Certified Action of the City of Raleigh Planning Commission

Case File / Name: SP-1-13 / Family Dollar Mitchell Mill Road

Nature of Case: The construction of an 8,320 square foot retail sales establishment on a 1.58 acre parcel zoned Shopping Center CUD. Planning Commission approval is required because the proposed retail use is within 400' of a residential use.

Staff Report

SP-1-13 / Family Dollar Mitchell Mill Road – Site Plan

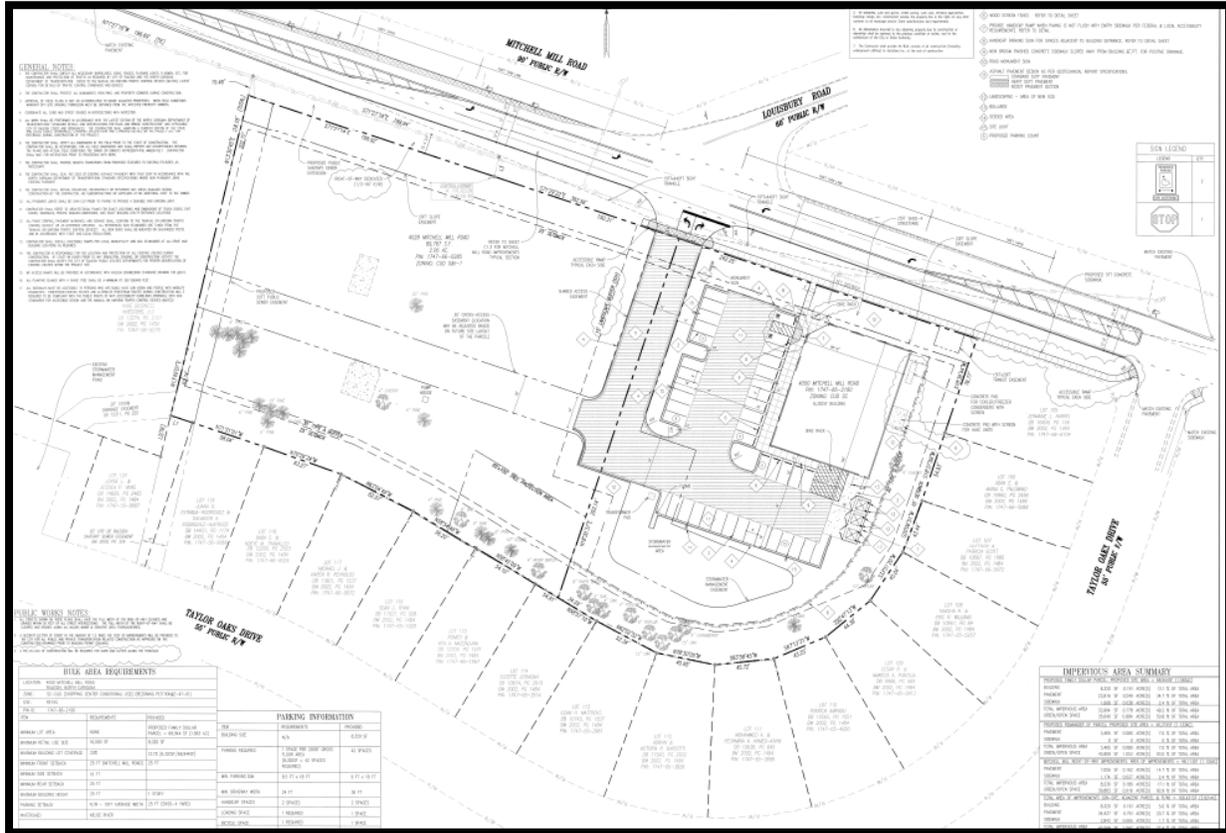
- (1) That the Planning Commission finds that this site plan meets the standards for approval of Code Section 10-2132.2(d);

- (2) That a stormwater control plan with a stormwater operations and maintenance manual and budget shall be approved by the Stormwater Engineer in compliance with Part 10 Chapter 9, including the designation of buffer areas and open space areas for stormwater purposes prior to grading or the approval of construction drawings whichever event comes first;
- (3) That a nitrogen payment must be made to a qualifying mitigation bank;
- (4) That prior to the issuance of a grading permit, the final tree protection plan must be approved by the Forestry Specialist in the Development Services Department. A tree protection fence shall be located around the critical root zones of all protected trees being used as credit located in the transitional protective yard. The tree protection fence must be located by the field and inspected by the Forestry Specialist;

- (5) That ½ of a 90' right-of-way with a 20' slope easement be dedicated on Mitchell Mill Road and be shown on all maps for recording;
- (6) That infrastructure drawings be approved by the Public Works Department and Public Utilities Departments;
- (7) That the developer shall pay to the City a stormwater facility replacement fund payment equal to twenty-four percent (24%) of the estimated cost of constructing all stormwater control facilities shown on the development plans;
- (8) That all stormwater control measures and means of transporting stormwater runoff to and from any nitrogen and stormwater runoff control measures shall be shown on all plats for recording as private drainage easements and the plats shall contain the following note: "All private storm drainage easements & stormwater measures will be maintained by the homeowner association;

- (9) That a fee-in-lieu for the construction of ½-65' roadway section with curb and gutter and ½-5' sidewalk from the drive opposite Louisbury Road to the west property line of Tract 1 be paid to the Public Works Department;

- (10) That a cross access agreement between the subject parcel, lot 1, (deed book 14594 Page; Pin Number 1747663190) and the parcel to the adjacent west, lot 2, (Deed Book 14594 PG 0262; Pin number 1747661230) be recorded;

- (13) That a deed is recorded for the construction of an off-site sidewalk easement on the property to the adjacent east (Deed Book 10608 PG 0156);
- (14) That an off-site landscape easement deed be approved by the City Attorney on the parcel to the adjacent west DB 14594 PG 0262; Pin Number 1747663190 and recorded be recorded;

- (15) That the property owners shall prepare a transit easement deed approved by the City Attorney measuring fifteen (15') feet by twenty (20') feet at a location along Mitchell Mill Road approved by City of Raleigh transportation services. The transit easement shall be recorded with the Wake County Register of Deeds Office, and a recorded copy of the transit easement deed shall be present to the Planning Department prior to issuance of a building permit;

The Commission suggests that applicant to include additional windows on Mitchell Mill Road building elevation	The store needs the wall space for shelving, coolers, etc which does not allow enough room to add additional windows.
The Commission recommends applicant to consider ways to provide greater screening of the mechanical and HVAC equipment with materials that are complementary to the building colors and design and additional vegetative screening. Use of one 6' fence to screen all mechanical units is another suggestion to help mitigate noise to neighboring residential properties	One continuous fence can be used to hide all mechanical units. The fence would be located along the edge of the required buffer which contains a 6' high fence and plantings. No additional plantings should be required along the mechanical unit fence.
The Commission encourages the use of a greater variety of landscape species, as well as a more consistent and uniform pattern for planting	The transitional protective yard contains 3 types of shrub species - Azalea - India Hawthorn - Glossy Abelia

The Commission recommends the applicant to consider the potential location of future buildings on the parcel to the west when locating driveway stub, as proposed location may not allow flexibility for future development to the west	The stubbed driveway was relocated further south on the site
The Commission recommends the applicant to incorporate additional landscaping and streetscape elements, such as bike racks, benches and/or other street furniture, in front of the building on Mitchell Mill Road near the building entrance	A bicycle rack was added near the entrance of the building.

Cross access is being proposed

A 25' SHOD-4 yard is proposed along Mitchell Mill Road

A 30' Type B Transitional protective yard and 6' fence will be constructed to screen refuse containers from the single-family residences to the adjacent east.

A 15'x20' transit easement is proposed along Mitchell Mill Road

No parking is proposed within 25' of Mitchell Mill Road

Building is located further than 25' feet from Mitchell Mill Road. A sidewalk connects the building to the Public Sidewalk along Mitchell Mill Road.
